Project Name: 7-11 Store - Convenience Store and Professional Office

# REVIEW SHEET SUMMARY

FILE NO. 7-83 TITLE HEADING Development in H.O. DUE DATE 2/11/83

ACTIVITY - PETITIONER - LOCATION - PHASE - ACRES Petitioner: Larjer Investments Ltd./  
Gerald Pittsinger. Location: Lot 4 of Northside Park Sbudivision. A request for a  
convenienc store and professional office in a highway oriented zone. Consideration of develop-  
ment in H.O.

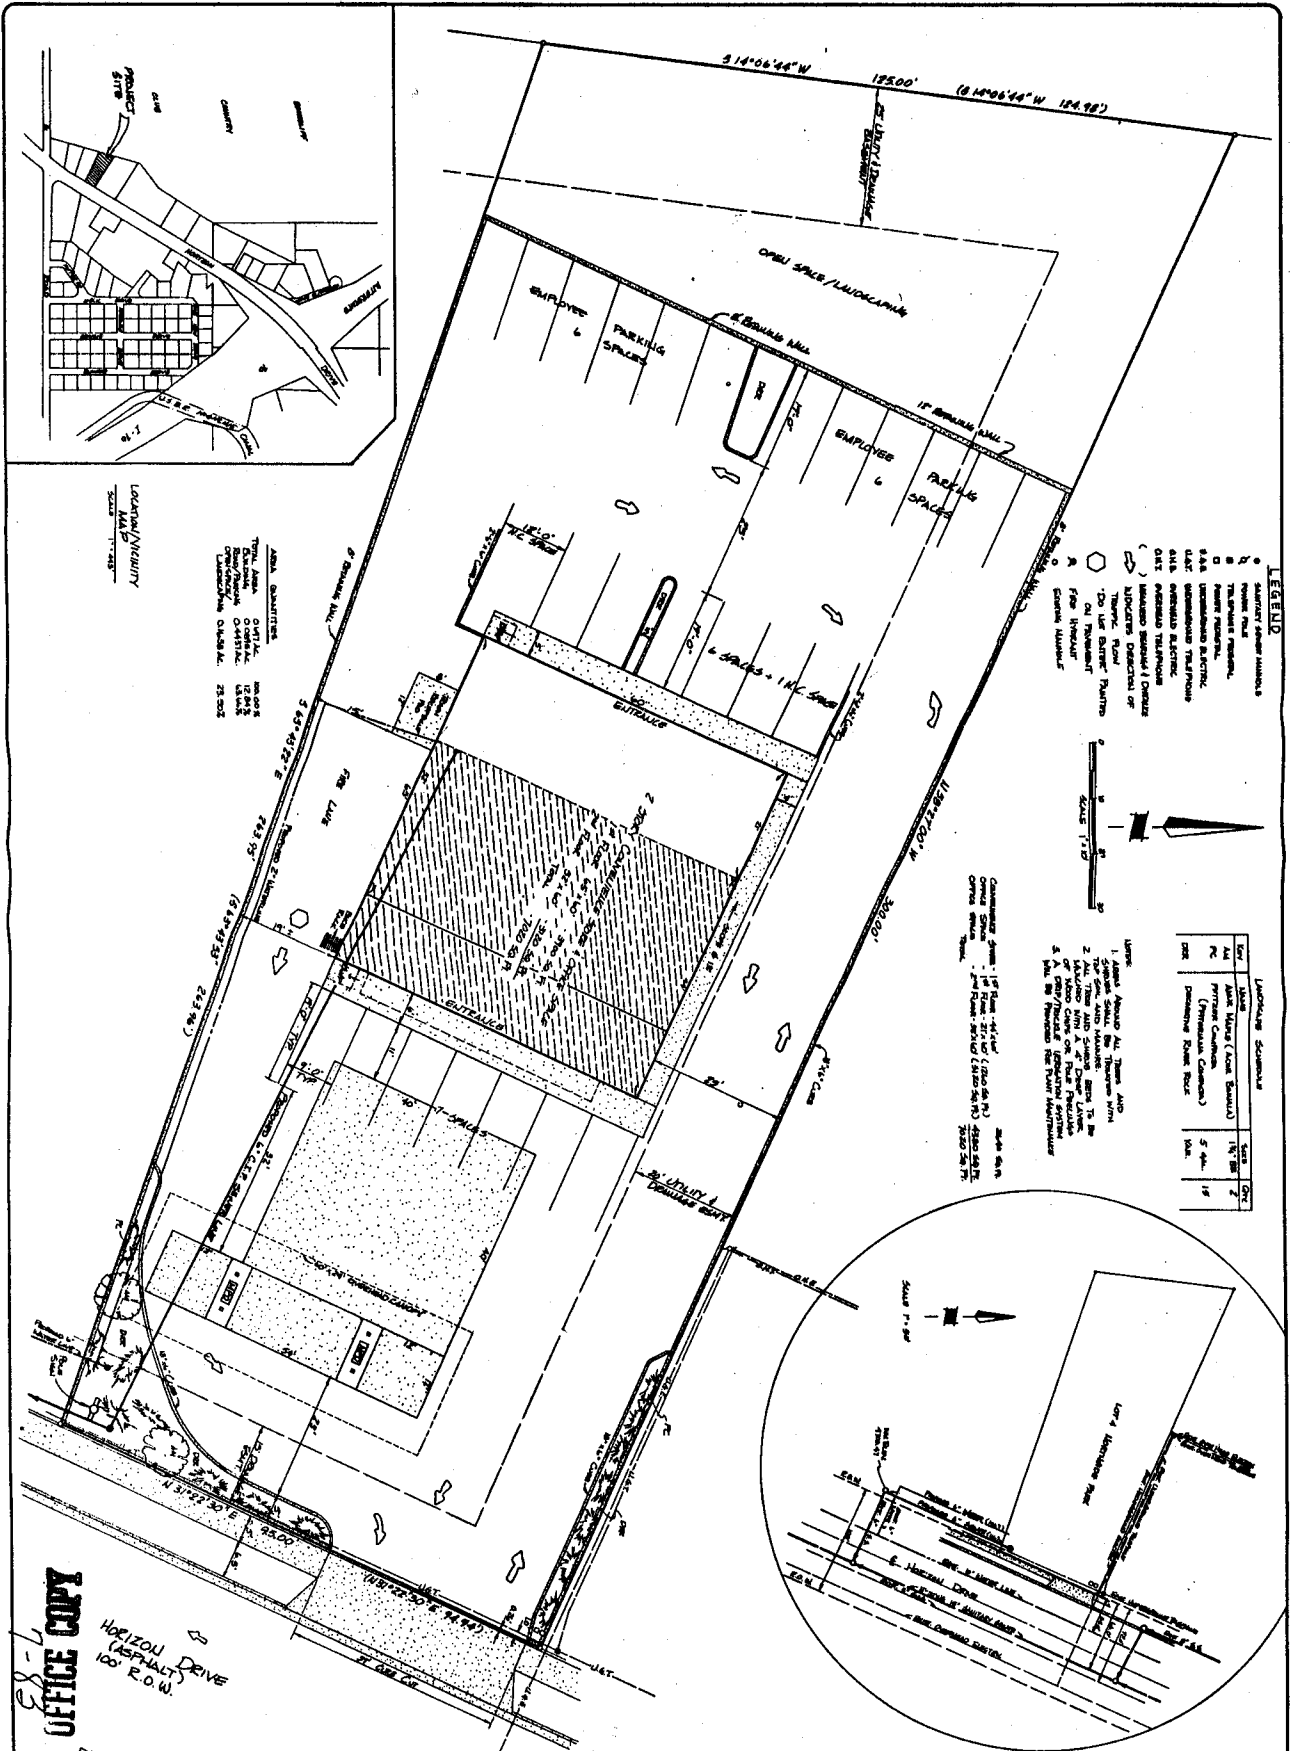
<u>DATE REC.</u>	<u>AGENCY</u>	<u>COMMENTS</u>
2/2/83	City Utilities	None
2/9/83	City Fire	The Fire Dept. will accept this plan as shown with the exception of the fire hydrant to be placed closer to the curb. Place fire hydrant approximately 4' from curb. Fire hydrant placement agreement signed.
2/10/83	Public Service	Gas: No objections. Electric: PSCo will require a fifteen (15) foot wide utility easement adjacent to Horizon Drive across Lot #4 from the owners.
2/14/83	Mountian Bell	No objections.
2/14/83	City Parks	None
